Overview: The initial production release of the FTI-TLK1 harness has an issue where in some vehicles the secondary power input to the CN1 connector will overload the associated vehicle circuit, causing a fuse to blow. This issue affects the initial release of harnesses and is already being addressed in production. A field correction procedure is detailed below in Figure 1.

FTI-TLK1 Type 3C4 - Vehicle Coverage & Preparation Notes

FTI-TLK1 Type 3C4 - Installation Notes & Wiring Diagram

Figure 1: Step by step adapter correction

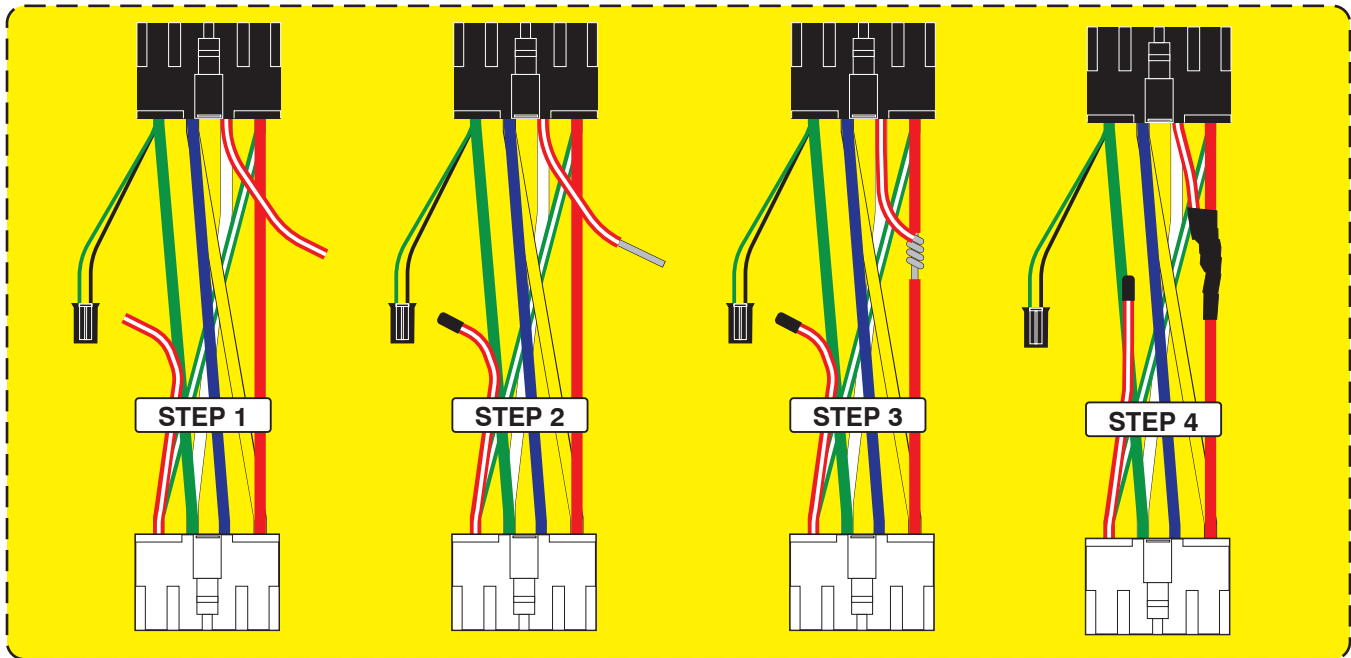
Issue: The secondary power circuit can overload some vehicle ignition switch circuits, causing a blown 5A/7.5A AM1 fuse, potentially disabling the vehicle and leaving the consumer stranded. Affected adapters are illustrated below in figure 2.

- 1.) Select the applicable CN1 adapter, isolate the RED/WHITE power wire, cut wire approximately 4" from the BLACK plug
- 2.) Insulate the wire still connected to the WHITE plug using heat shrink tubing, and strip the insulation on the other wire end
- 3.) Strip a portion of the insulation from the RED wire, attach the stripped RED/WHITE to the exposed RED wire, solder together
- 4.) Apply insulating tape to the soldered connection and secure the cut ends back to the bundle of wires created by the adapter
- 5.) Correction complete, you may safely proceed to finish your installation

Figure 2: Supplied CN1 Harness Adapters

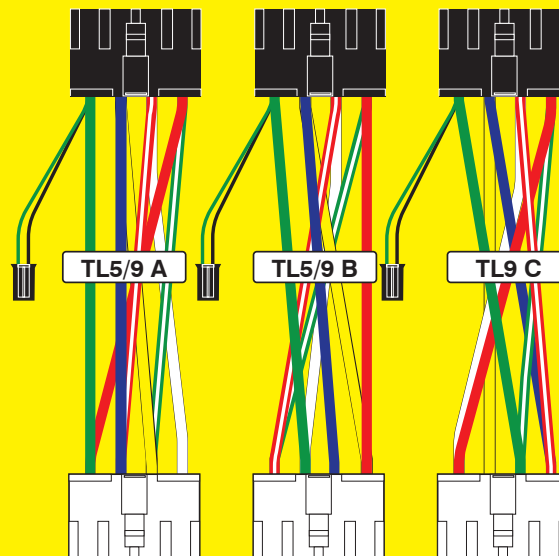
Incorrect power provisions with the potential to overload vehicle ignition supply circuit, resulting in blown AM1 fuse.
